Permit Application Review

Permit No. 2018-131
Received complete: December 26, 2018

Applicant: Tim Rybak; Bloomington Public Schools
Consultant: Mandy Backstrom; Anderson-Johnson Associates
Project: Building Addition and new Chiller Enclosure at Valley View Middle School
Location: 8900 Portland Avenue: Bloomington
Rule(s): 4 and 5
Reviewer: BCO

GRADING AND DRAINAGE PLAN, SEDIMENT CONTROL PLAN

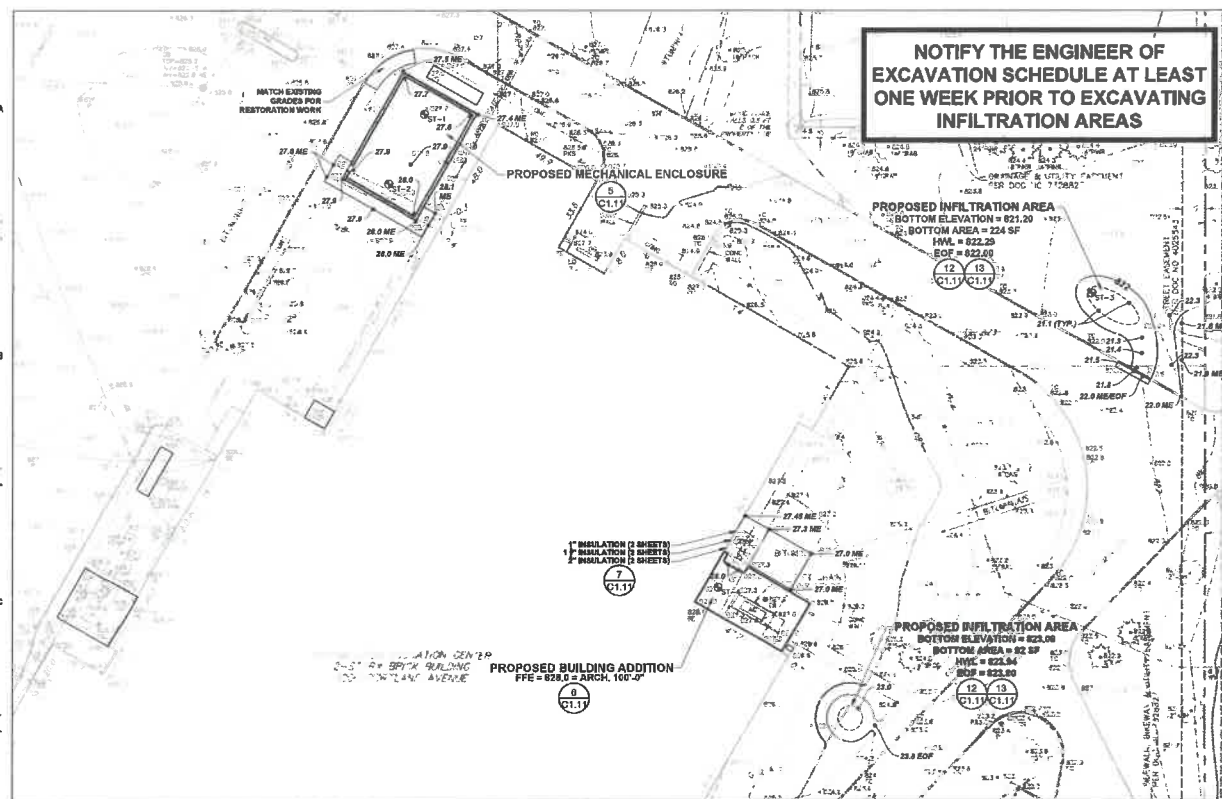
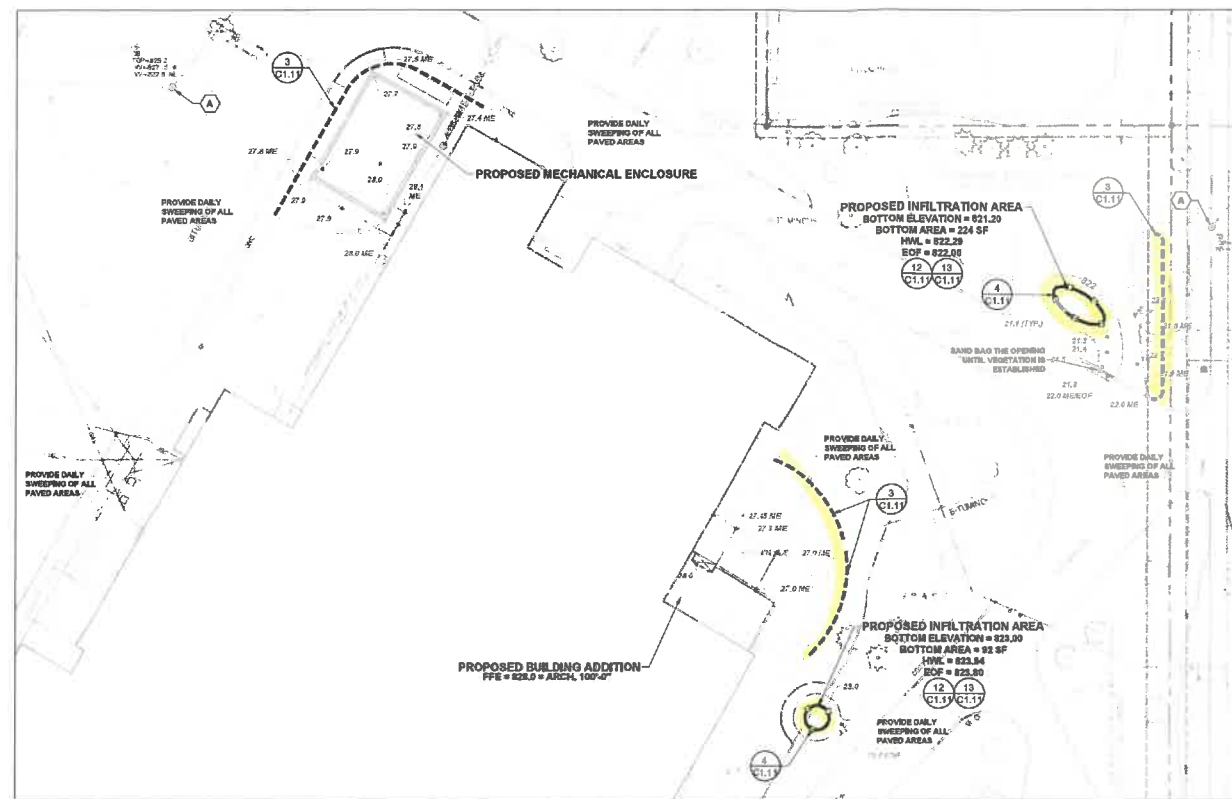
An infiltration volume of 483 cubic feet is required from the 5,271 square feet of new and disturbed and reconstructed impervious area. The soils information provided indicates the underlying soils is silty sand (SM) having an infiltration rate of 0.45 inches/hour using the

Minnesota Storm Water Manual. A volume of 621 cubic feet will be provided by the Basins (483 cubic feet required). An area of 262 feet is required, with an area of 1,106 square feet provided, for volume retention using this infiltration rate. This is based on a maximum allowable inundation depth of 1.8 feet within the Basins with a required drawdown in 48 hours (4.3.1a (ii)).

The borings submitted indicate that groundwater was not encountered to elevation 810 +/- M.S.L. The bottom of Basin #1 is 821.1 M.S.L., a separation of 11.1 feet. The bottom elevation of Basin #2 is 823 M.S.L., a separation of 13 feet. A three (3) foot separation is required between the bottom of an infiltration facility and groundwater.

The HydroCAD modeling provided shows elevation 822.3 M.S.L. as the calculated 100-year frequency flood elevation for Basin #1 and 823.9 M.S.L. for Basin #2. The finished floor of the existing building is 828 M.S.L. A 5.7 foot separation will be provided between the existing finished floor elevation of the school and the flood elevation of Basin #1. For Basin #2, a 4.1 foot separation will be provided between the finished floor elevation of the school and the flood elevation of Basin #2. District Rule 4.3.3 states that a stormwater management facility must be constructed at an elevation that ensures that no adjacent habitable building will be brought into noncompliance with a standard in subsections 4.3.3 c, requiring at least two feet of separation provided between the 100-year high water elevation of a constructed facility and the low floor elevation of a structure. Rule 4.3.3 is met.

In accordance with Rule 4.3.1a (i), the pre-treatment of runoff prior to the infiltration area will be provided by runoff sheet-flowing across pervious turf area ranging from 20 feet to 100 feet from the project areas to the basins. The turf grass acts as a filter providing the required pretreatment of storm water upstream of an infiltration area.

The submitted erosion and sediment control plan includes silt fence at the limits of construction. The project contact is Mandy Backstrom, Anderson-Johnson.
